City of Santa Fe, New Mexico

memo

2025-011246-HDRB. 532 Calle Corvo. Downtown & Eastside Historic District. Contributing. John A. Padilla, agent for Susan McShane Salomone, owner, requests approval to construct a 620 sq. ft. addition to the main house and 518 sq. ft. addition to the garage. Four exceptions are requested to 14-5.2(D)(5)(a)(i) removal of windows and doors of a contributing structure, 14-5.2(D)(2)(d) additions are not permitted to the side of the existing footprint unless the addition is set back a minimum of ten (10) feet from the primary facade, the addition shall not exceed fifty percent of the square footage of the existing footprint and shall not exceed fifty percent of the existing dimension of the primary facade.

Figure 3. Existing and Proposed Floor Plan of the garage structure.

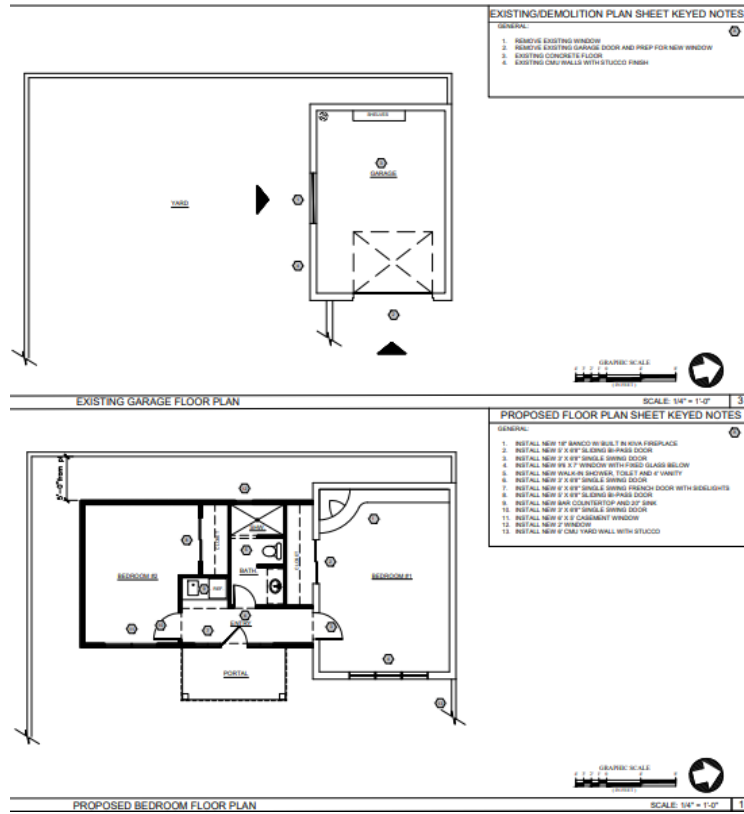
Staff Response: Staff has evaluated the applicant's response and finds that the criterion has not been met. The proposed design completely changes the current contributing condition of the Garage and will threaten the status.

Staff Response: Staff has evaluated the applicant's response and finds that the criterion has not been met. The proposed changes to the contributing garage structure will completely change the use and design in which the Board made a previous motion to preserve. The current request for alterations on the main residential structure do not need an exception request and should be adequate to meet the needs of the homeowners.

Staff Response: Staff has evaluated the applicant's response and finds that the criterion has not been met. The applicant has provided an aesthetically pleasing and code compliant design option for the renovation of the garage. If the garage was a non-contributing structure to the Downtown and Eastside Historic District no exceptions would be required and the design option would meet the letter of the code, however in the previous status hearing for this property the Board made a motion to upgrade the status to contributing status to preserve the current condition of the structure and the proposed design completely changes the historic form in which the Board is trying to preserve.

Staff Response: Staff has evaluated the applicant's response and finds that this criterion has not been met. The proposed 518 sq. ft. addition envelopes the current 337 sq. ft. Garage and completely changes the current contributing condition of the garage which will threaten the status.

Staff Response: Staff has evaluated the applicant's response and finds that the criterion has not been met. The proposed 518 sq. ft. addition changes the current 337 sq. ft. contributing Garage structure and changes the use and design in which the Board made a previous motion to preserve. It is the expectation that building character be maintained; the large addition completely changes the character of the structure. Incremental changes such as this can establish a precedent and cause a much greater degree of change across all historic districts.

Staff Response: Staff has evaluated the applicant's response and finds that the criterion has not been met. The proposed 518 sq. ft. addition changes the current 337 sq. ft. contributing garage. The applicant has provided an aesthetically pleasing and code compliant design option for the renovation of the Garage. If the garage was a non-contributing structure to the Downtown and Eastside Historic District no exceptions would be required and the design option would meet the letter of the code, however in the previous status hearing for this property the Board made a motion to upgrade the status to contributing status to preserve the current condition of the structure and the proposed design completely changes the historic form in which the Board is trying to preserve.

Figure 4. Existing and Proposed East Elevation and Primary Facade of the main residential structure.

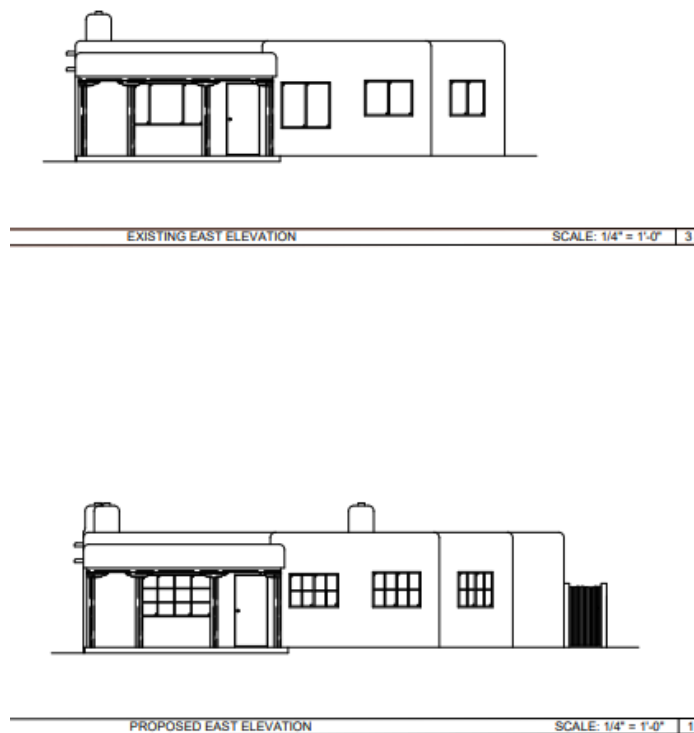
Exception to 14-5.2(D)(5)(a)(i) to narrow a historic window opening on the primary facade of a contributing structure from 4’-07” wide by 4’-04” high to 4’-07” wide by 3’-02” high:

Staff Response: Staff has evaluated the applicant’s response and finds that the criterion has been met. The proposed narrowing of the historic window opening from 4’-07” wide by 4’-04” high to 4’-07” wide by 3’-02” high, will not adversely impact the historic contributing status or primary façade of the structure. The proposed divided lite window is in compliance with the historic district standards.

Staff Response: Staff has evaluated the applicant's response and finds that the criterion has been met. The proposed narrowing of the historic window opening will provide the owner with the upgraded energy efficiency requested while maintaining the historic district standards.

Staff Response: Staff has evaluated the applicant's response and finds that the criterion has been met. The proposed narrowing of the historic window opening will not adversely impact the historic contributing status or primary façade of the structure. The proposed divided lite window is in compliance with the historic district standards.

Figure 5. Existing and Proposed East Elevation and Primary Facade of the garage structure.

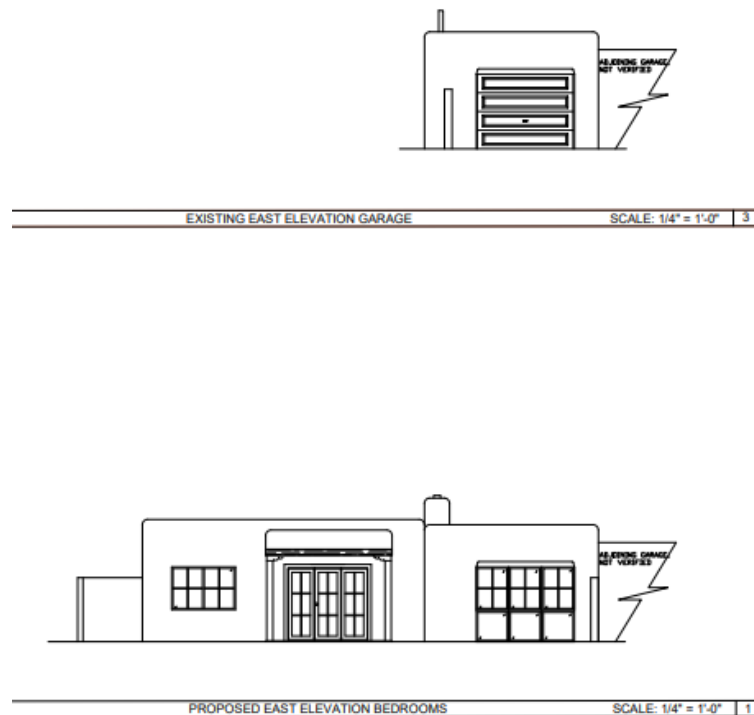
Staff Response: Staff has evaluated the applicant's response and finds that the criterion has not been met. The proposed addition exceeds fifty percent of the primary façade's existing

dimension by 10'-6" along the east façade which changes the overall character of the Garage which the Board has determined is worth preserving.

Staff Response: Staff has evaluated the applicant's response and finds that the criterion has not been met. The proposed impact on the primary façade should be reconsidered and not diminish the character defining presence on the streetscape.

Staff Response: Staff has evaluated the applicant's response and finds that the criterion has not been met. The proposed addition and impact on the primary façade should strengthen the contributing garage not completely change the look and use of what the Board has determined is worth preserving.
